**City of Richmond**  
Urban Development Division

**Report to Committee**

RZ 04-272331

**Re:** Application by Sungrand Development Ltd. for Rezoning at 11651 / 11671 /  
11691 / 11711 Steveston Hwy. from Single-Family Housing District,  
Subdivision Area E (R1/E) to Townhouse District (R2-0.6)

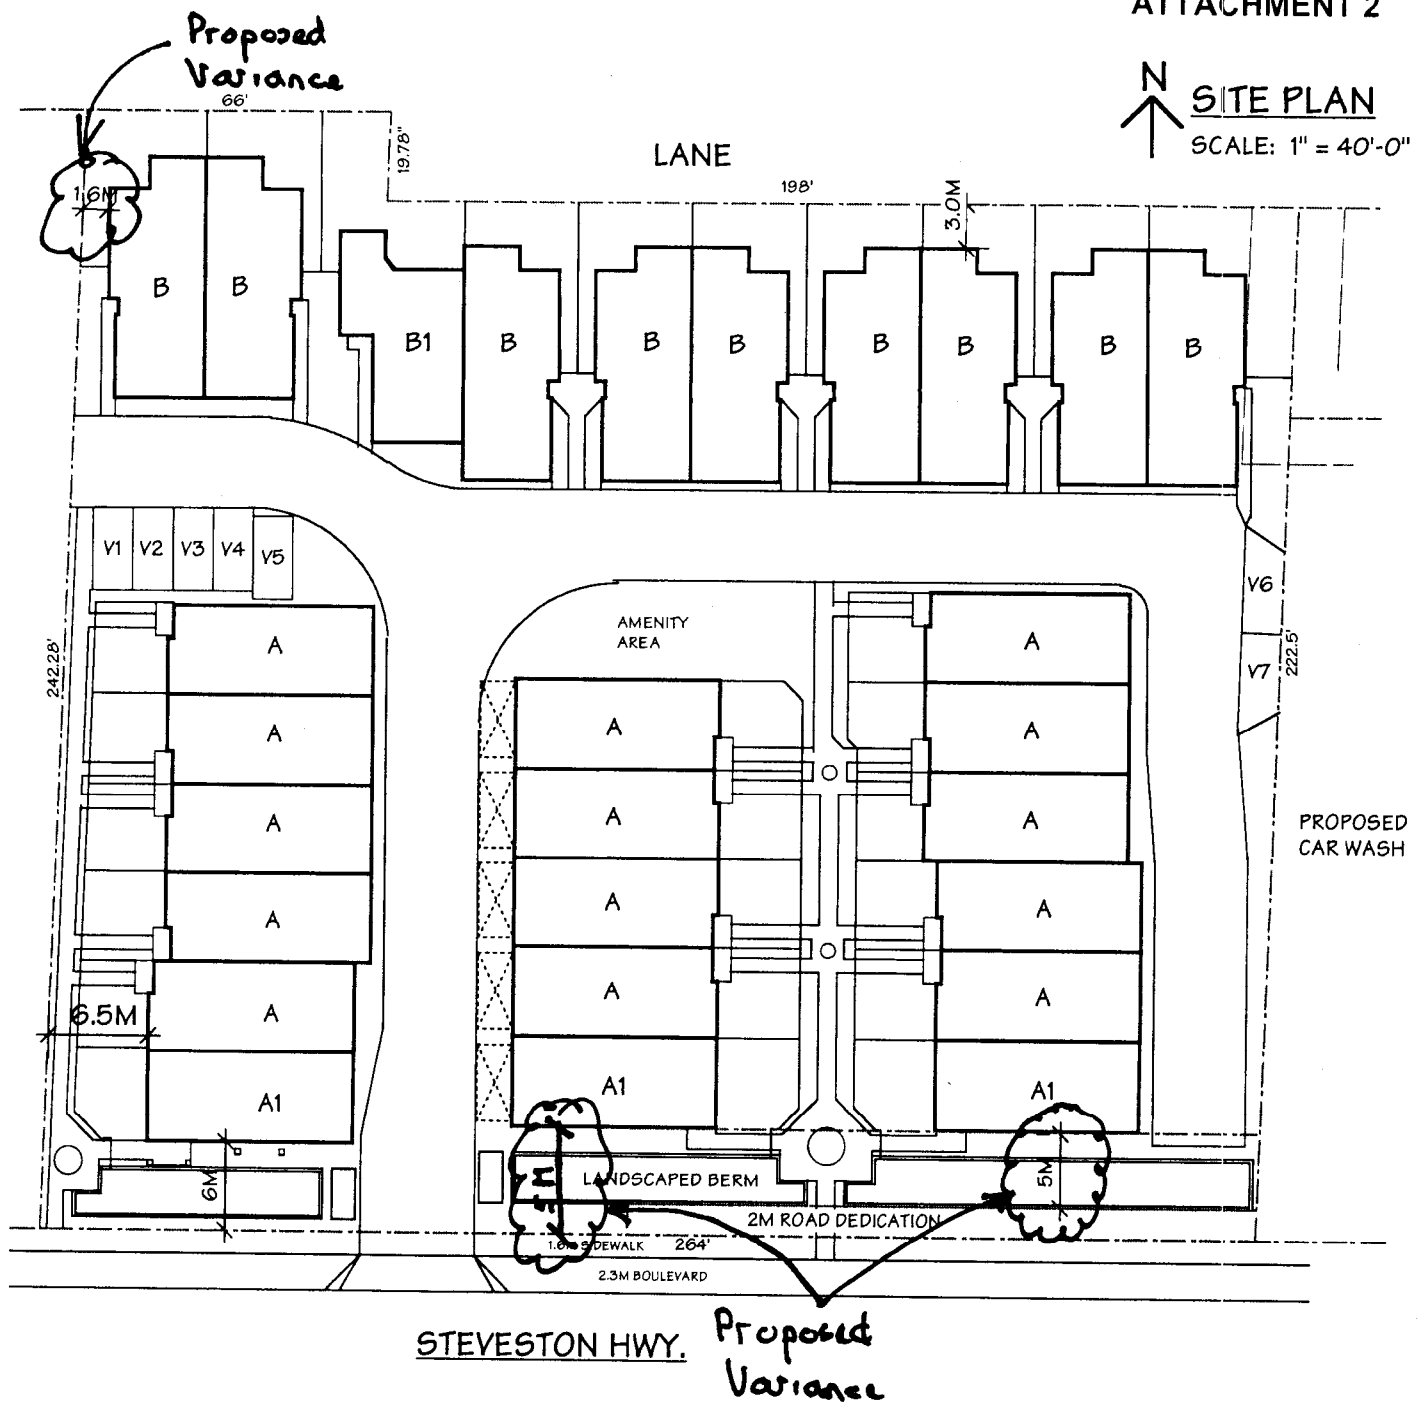
Comments on the site plan dated Sept 14, 2005:

1. Require land dedication of 2-m width along the site's south frontage along Steveston Hwy. from the site's eastern property line to approximately 42 m west of the site's eastern property line.

2. Frontage improvements (including sidewalk, grass-treed Boulevard) are required along the site's Steveston Hwy. frontage.
3. Register on title a 7.5m wide Public Right-Of-Passage (PROP) Right Of Way (ROW) from Steveston Hwy., that tapers at a 5:1 ratio starting at 5m from the site's southern property line along Steveston Hwy, getting down to a 6m PROP at the interior intersection. A 6m wide PROP is also required for the East-West portion of the internal roadway that runs between the interior intersection and the western property line.

4. The entrance driveway is to be 7.5-m wide for a minimum length of 5 m measured from the southern property line into the site. The paved area dimensions should conform to the PROP noted above.

5. Conform to City's Parking Bylaw on the number and dimensions of the off-street parking. Development Permit plans should indicate the parking stall dimensions on a scaled drawing. One handicapped parking stall is required.
6. For the Development Permit, demonstrate how a loading truck (i.e., SU-9) could be accommodated on site. Show vehicle turning paths on a scaled drawing.
7. Prior to issuance of a Building Permit, a construction parking and traffic management plan is to be provided to the Transportation Department to include: location for parking for services, deliveries, workers, loading, application for request for any lane closures (including dates, times, and duration), and proper construction traffic controls as per Traffic Control Manual for Works on Roadways (by Ministry of Transportation) and MMCD Traffic Regulation Section 01570.

There is insufficient info to provide detailed urban design comments. The applicant is advised that the following concerns arise from the site plan and should be addressed in the Development Permit application in addition to design issues:

- Revise site plan to conform to required setbacks and provide required accessible parking space.
- Most of the existing trees are proposed to be removed. All of the perimeter trees and the tree located in the pedestrian street should be considered for retention if viable. To this end, remove V6 as only 6 visitor parking spaces are required.
- There is a missed opportunity to provide back yards for the West units. Careful design will be needed to address CPTED issues and form and character of the proposed narrow pedestrian connection. Consider orienting pedestrian front entries to much more visible and prominent manoeuvring aisle.
- Improve views into and within development.
- Locations and details are required for recycling, garbage, mailbox and servicing closets/rooms.
